TRANSPORT IMPACT ASSESSMENT

PROPOSED AGED CARE FACILITY

CORNER OF KARAKUL ROAD AND ANGORA ROAD, HAMILTON

(Response to EDQ Further Issues Letter, dated 21 August 2024)

FIGURE 5.1 – PROPOSED VEHICLE CROSSOVER LAYOUT AND DIMENSIONS (KARAKUL ROAD)

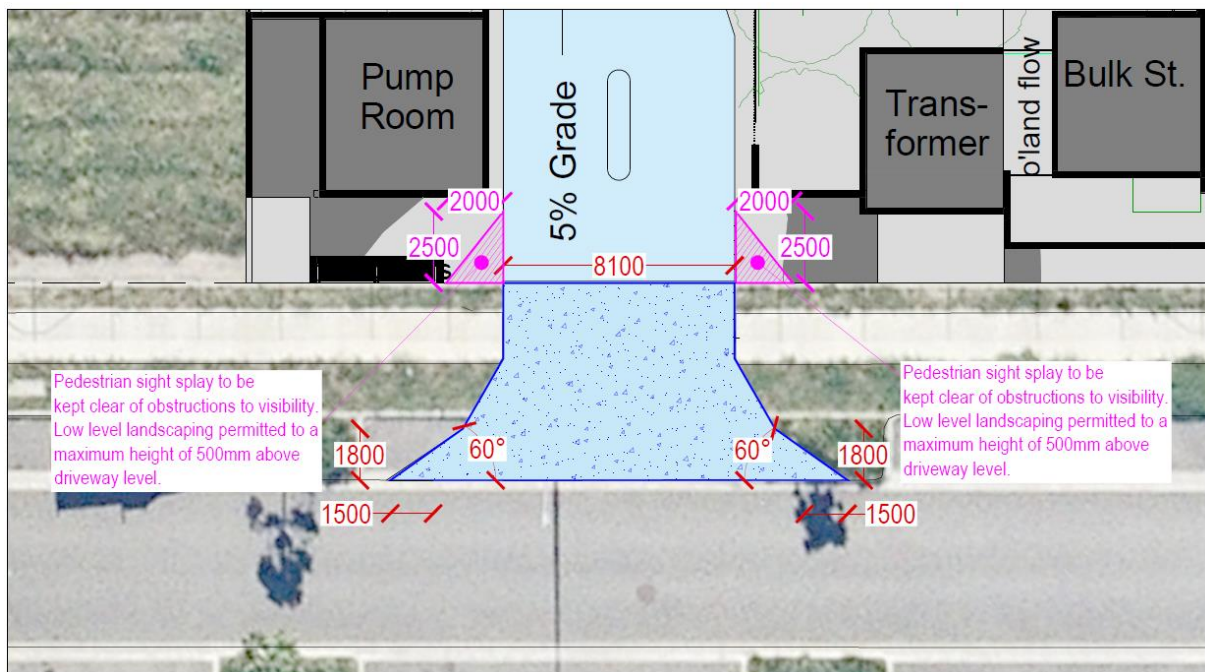
b) Driveway

Section 5 of the Traffic Impact Assessment report contains errors, such as referencing an existing driveway that does not exist and it states a crossover width that is inconsistent with what is dimensioned on the referenced figure. Submit an amended Traffic Impact Assessment report to correct the abovementioned.

It is noted that the vegetated buildout shown on the western side of the driveway is not sufficiently sized to offset the loss on the eastern side. Submit amended engineering plans to demonstrate the vegetated buildout be extended to meet the driveway flare.

Section 5 has been amended.

Vehicular access will be located from a single crossover located at the northern end of the Karakul Road frontage. As shown in Figure 5.1, it is proposed that a Type B2 (8.1m) crossover be provided.

It is noted that the existing vegetated build out will be modified to suit the new vehicle crossover arrangements.

FIGURE 6.1 – SWEEP PATHS OF REAR LIFT REFUSE COLLECTION VEHICLE AT ACCESS DRIVEWAY

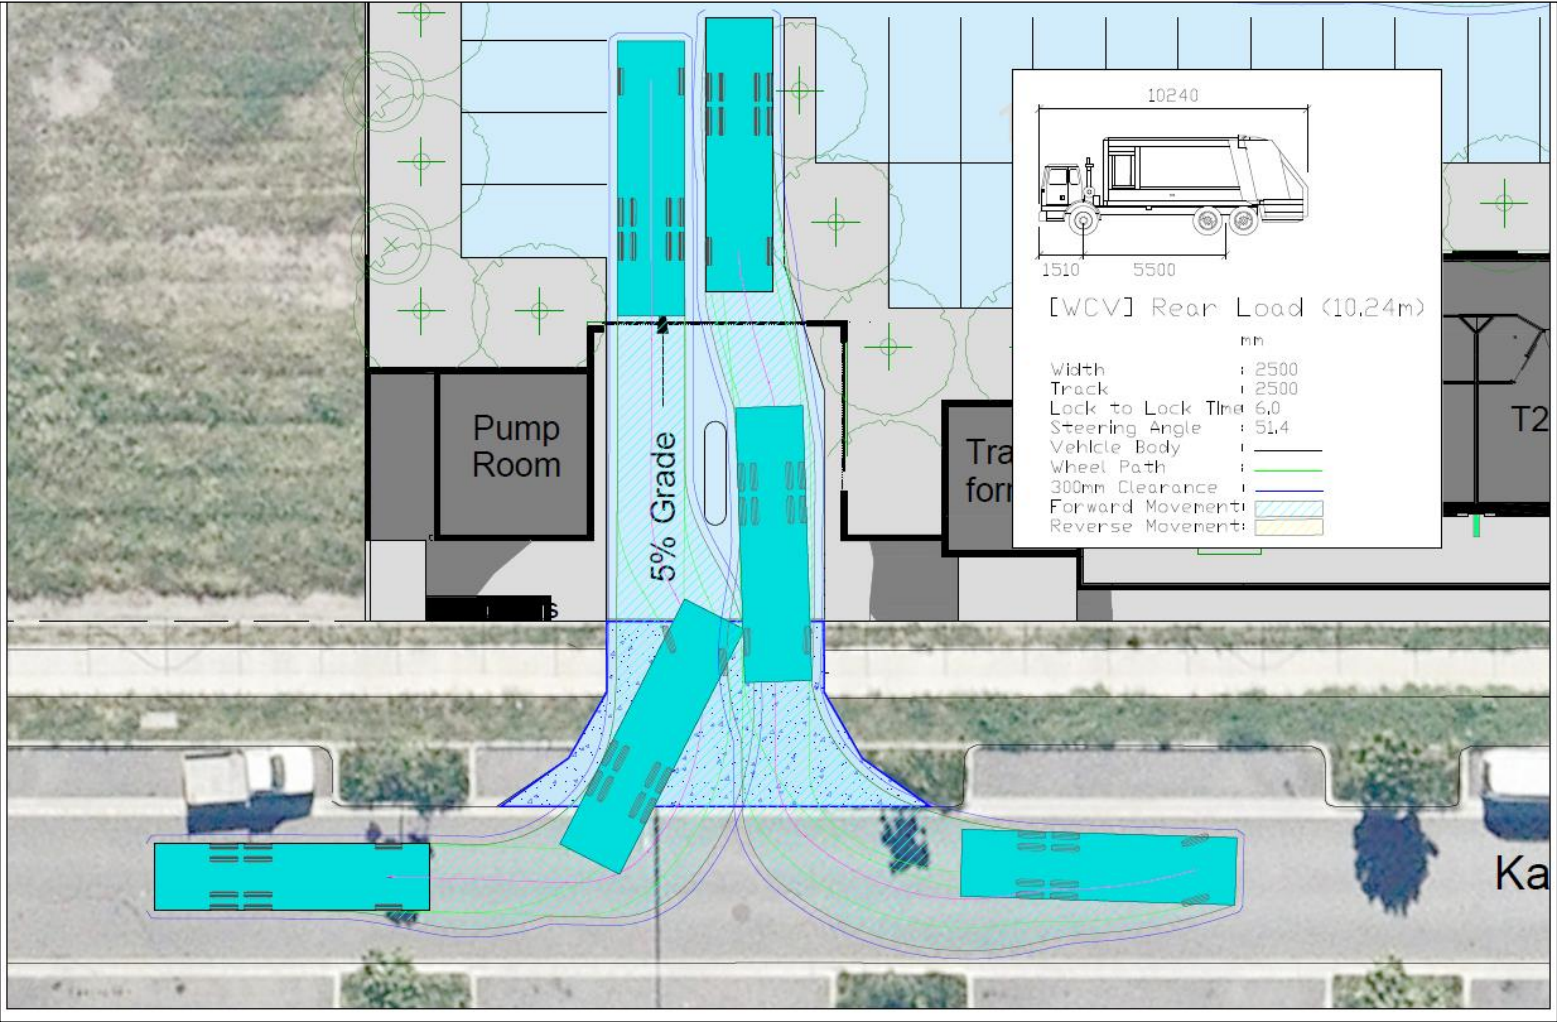
Furthermore, the swept path analysis references rear load RCV, however the report conclusion references a front loading RCV. It is noted the operating clearance for front loading RCV is significantly higher (as detailed in the Refuse PSP). Clarification and revised swept paths are required to demonstrate the proposed service vehicle and comply with the abovementioned requirements.

As shown in Figures 6.1 and 6.2, the proposed loading facility satisfactorily allows for access by rear lift Refuse Collection Vehicle. The largest delivery vehicles will be smaller than an RCV.

FIGURE 6.3 – SWEEP PATHS FOR A HEAVY RIGID VEHICLE (HRV)

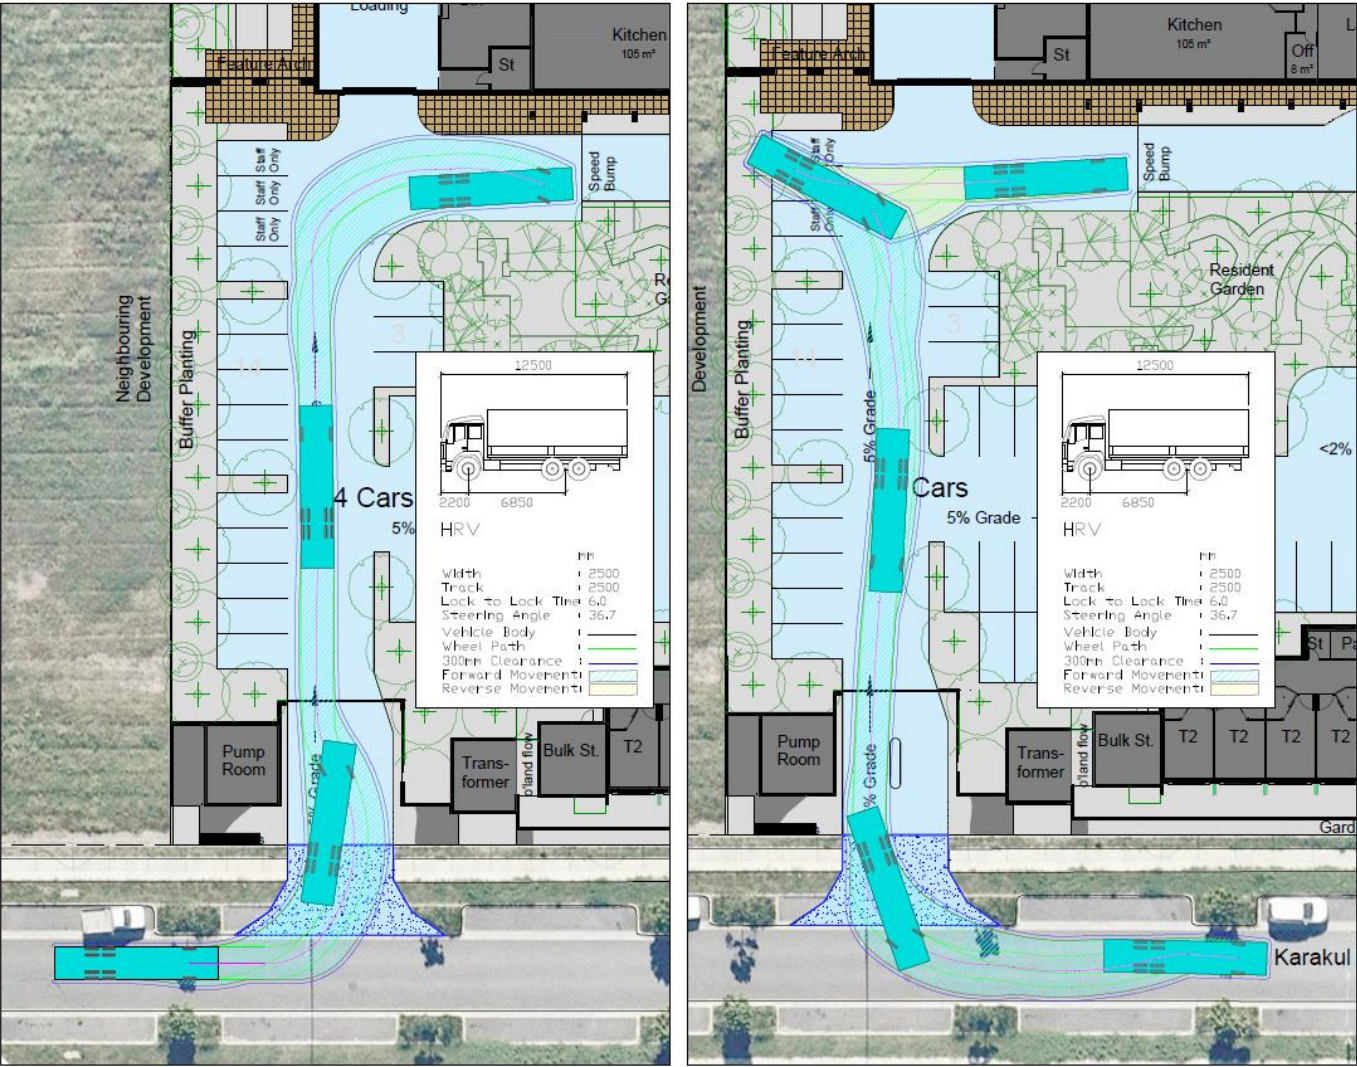
The occasional service vehicle for the proposed development, based on the Transport, Access, Parking and Servicing (TAPS) Planning Scheme Policy (PSP) of Brisbane City Plan 2014 (City Plan), is an LRV. As mentioned in the Traffic Impact Assessment report, the 10.24m LRV is significantly smaller than the standard 12.5m LRV. Submit amended swept path analysis certified by RPEQ to demonstrate manoeuvring for LRV (Please note that the swept path analysis and 10.24 m LRV is not supported by Council).

In addition, the submitted materials are not clear to demonstrate the site can be suitably serviced by the relevant design vehicle, with any Porte-cochere structure to exceed the clearance requirements for RCV circulation to operate as shown in the Traffic Impact Assessment report. To ensure sufficient on-site waste collection can be serviced, a minimum of 4.5 meters vertical height clearance over the loading dock and drop-off areas must be provided.

The site plan has been modified so that a Heavy Rigid Vehicle (HRV) can access and manoeuvre on-site. This sized vehicle will not require regular access and will need to manoeuvre over four staff allocated parking spaces. This is considered to be satisfactory as management can arrange for those spaces to be kept clear when such a vehicle is scheduled to arrive.

In accordance with Table 1 of the TAPS PSP, a Residential Care Facility is required to make provision for Regular access by a Large Rigid Vehicle. The site plan has been modified so that a Heavy Rigid Vehicle (HRV) can access and manoeuvre on-site (refer to Figure 6.3). This sized vehicle will not require regular access and will need to manoeuvre over two staff allocated parking spaces. This is considered to be satisfactory as management can arrange for those spaces to be kept clear when such a vehicle is scheduled to arrive.
